Attachment 4  
Orcas Moon Cottages  
SUB16-02267

PROPOSED SITE PLAN, IMPACTS AND MITIGATION OVERVIEW

FINAL CRITICAL AREAS MITIGATION PLAN  
PROPOSED SITE PLAN, IMPACTS AND MITIGATION OVERVIEW  
ORCAS MOON COTTAGES  
KIRKLAND, WASHINGTON

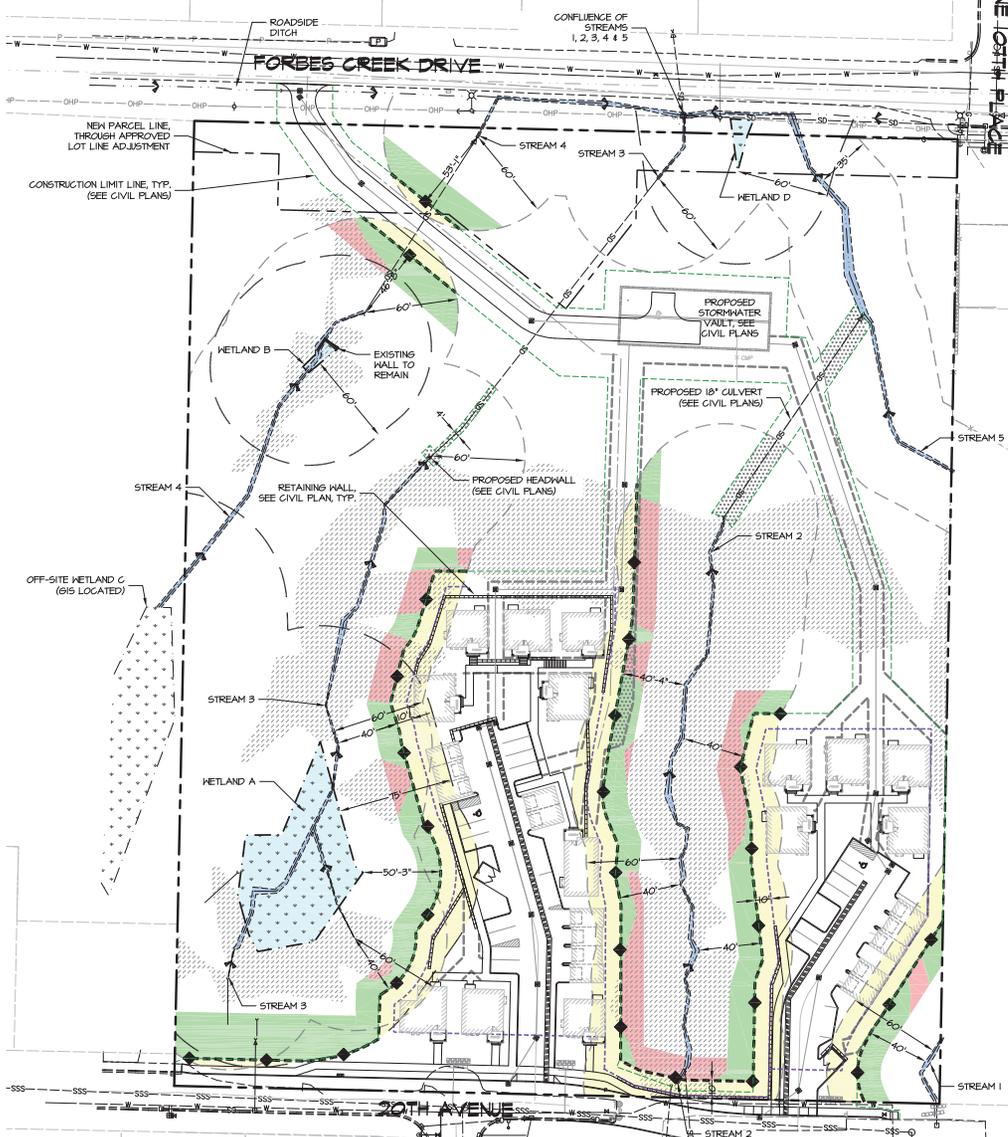
1. The proposed buffer reductions are substantial and we question whether there should be a limit to total buffer reductions allowed. At some point, the degree of buffer reductions negates the point of the buffer rule entirely. Referring to the Existing Conditions Plan, Sheet WI.0 by Talasaea dated 5/31/2017 and updated 11/3/17, the unmodified buffer and setback areas are less than 10 feet wide near the south end of the eastern housing cluster (between Stream 1 and Stream 2) and as narrow as 30 feet wide in the western housing cluster. This requires over 24,000 square feet of buffer encroachment plus modified setbacks to complete their plan. On Sheet 1 of 10 by the BlueLine Group, the preliminary plat plan indicates that 58.8% of the site is sensitive area buffer and the total buildable area is 103,694 square feet. The proposed buffer encroachment is almost 25% of the buildable area. Are there no limits on this?

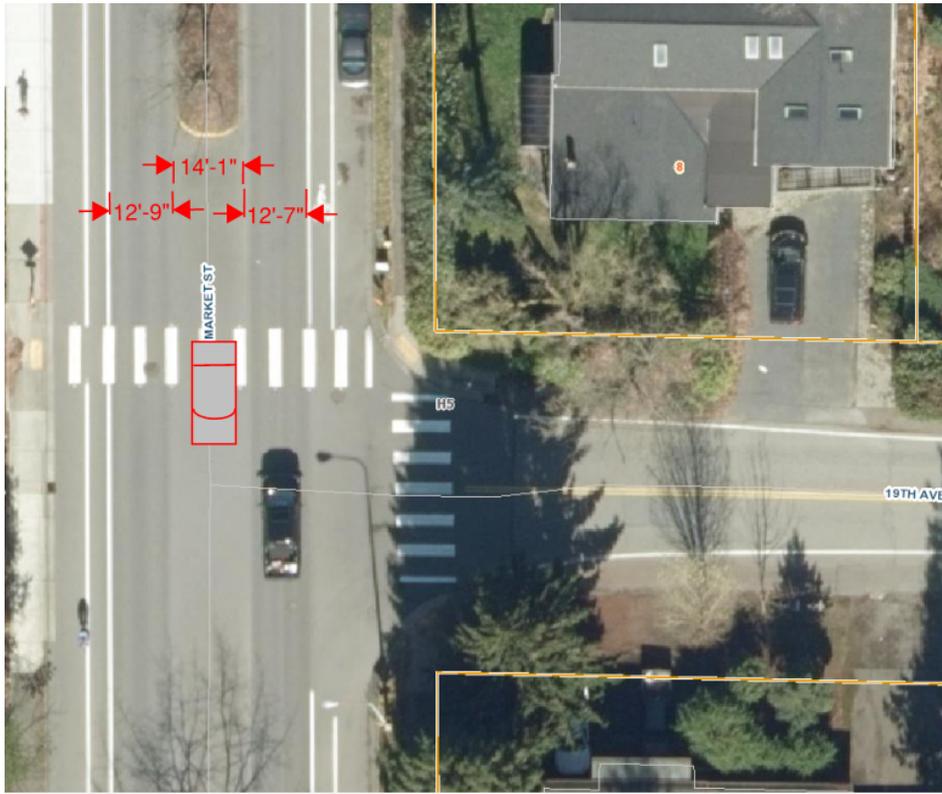
**Question 10:** Access: It appears that this development is approved for access off of 20<sup>th</sup>. I would like to confirm that this is and will ALWAYS be the only access. Having access across from my driveway could and probably would result in dangerous situations.
